12.3 Radiation Protection Design Features

The information in this section of the reference ABWR DCD, including all subsections, tables, and figures, is incorporated by reference with the following departures and supplements.

Figure 12.3- 74 Upper Drywell Shielding Radiation Dose Rates with Fuel Bundle on Refueling Bellows (Gy/h)

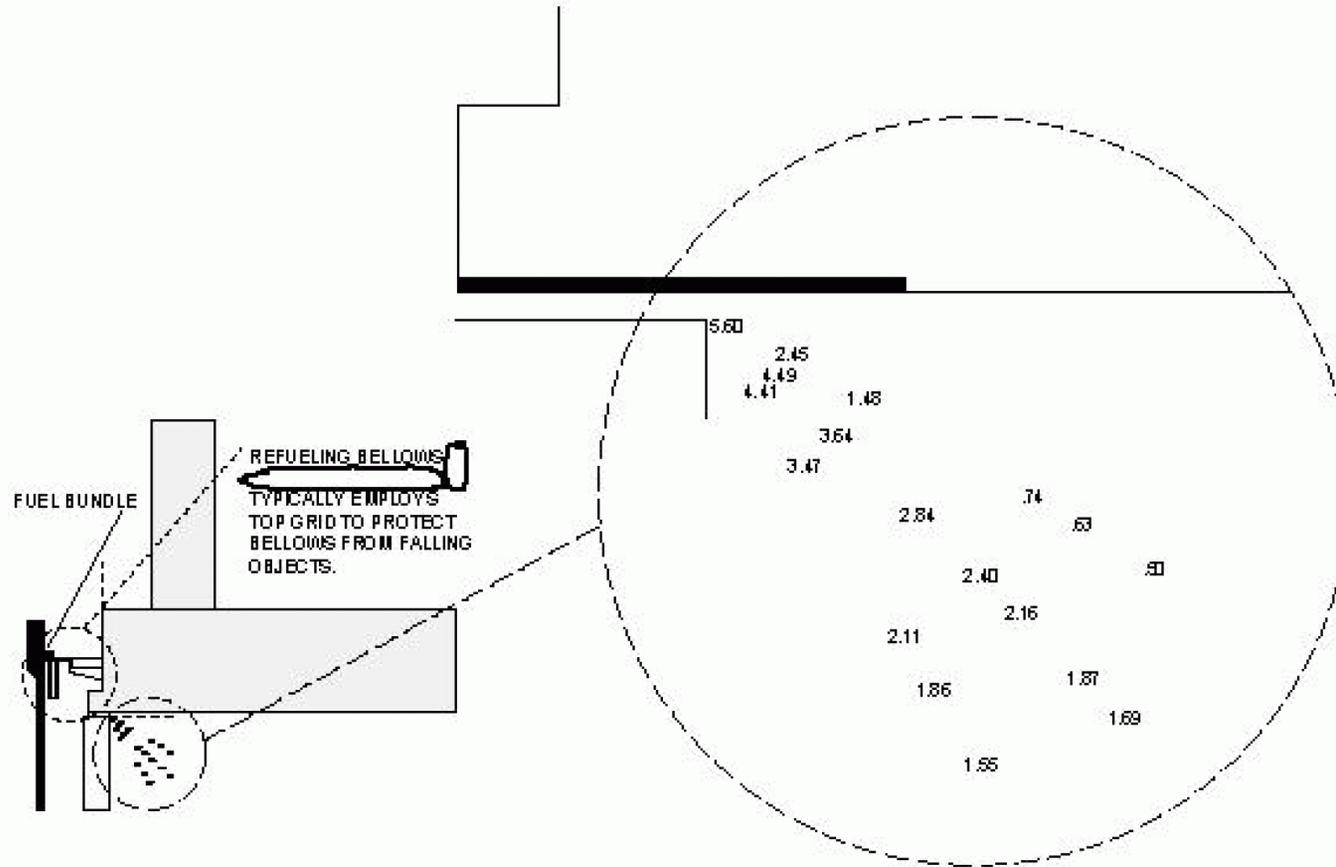
STD DEP Admin (Figures 12.3-1, 12.3-3, 12.3-6 and 12.3-74)
